# UNITED STATES PATENT AND TRADEMARK OFFICE

APPLICATION NO.	FILING DATE	FIRST NAMED INVENTOR	ATTORNEY DOCKET NO.	CONFIRMATION NO.
10/585,740	07/12/2006	Byeong-Ju Park	0630-2786PUS1	7844

<b>Office Action Summary</b>	<b>Application No.</b> 10/585,740	<b>Applicant(s)</b> PARK ET AL.	
	<b>Examiner</b> MINH D. A	<b>Art Unit</b> 2821

### **DETAILED ACTION**

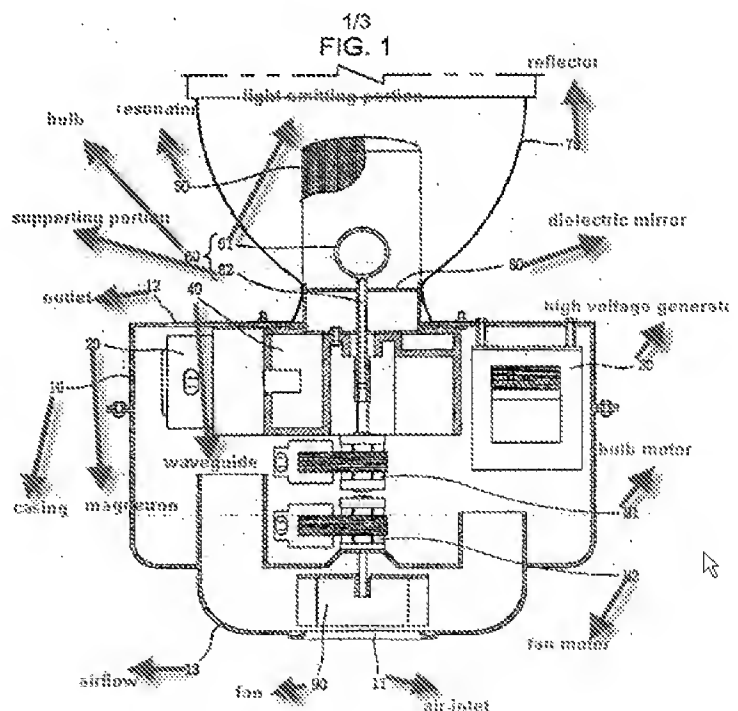
2. Figure 1 should be designated by a legend such as --Prior Art-- because only that which is old is illustrated. See MPEP § 608.02(g). Corrected drawings in compliance with 37 CFR 1.121(d) are required in reply to the Office action to avoid abandonment of the application. The replacement sheet(s) should be labeled "Replacement Sheet" in the page header (as per 37 CFR 1.84(c)) so as not to obstruct any portion of the drawing figures. If the changes are not accepted by the examiner, the applicant will be notified and informed of any required corrective action in the next Office action. The objection to the drawings will not be held in abeyance.

Regarding claim 1, AAPA discloses in figure 1 that, an apparatus for preventing leakage of a material inside a bulb (60) for a plasma lighting system, comprising: a bulb (60) containing a discharge material therein for emitting light as the discharge material becomes a plasma state by an electric field (emitting portion (61) with electric field and discharge material on the bulb(60); AAPA also discloses that, an external electric field of the bulb at a peripheral portion as shown in figure 1.

However, AAPA does not disclose that, a magnetic field forming portion for preventing the discharge material of a plasma state from being leaked by an external electric field of the bulb by forming a magnetic field at a peripheral portion of the bulb.

**FIG. 3**

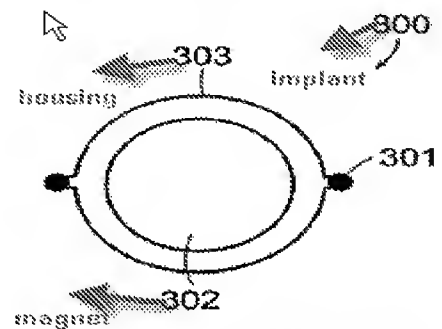
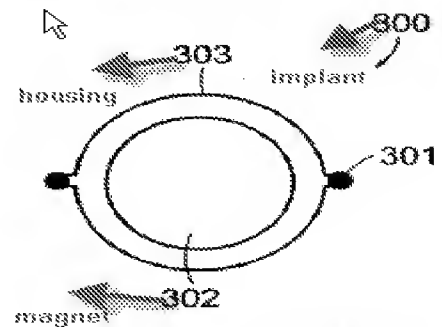
Zimmerling et al disclose, in figure 3 that, an implantable magnet (302) for apply magnet field and can be used to prevent leakage of material into the body of the implant (300).

Zimmerling et al disclose, in figure 3 that, an implantable magnet (302) for apply magnet field and can be used to prevent leakage of material into the body of the implant (300).
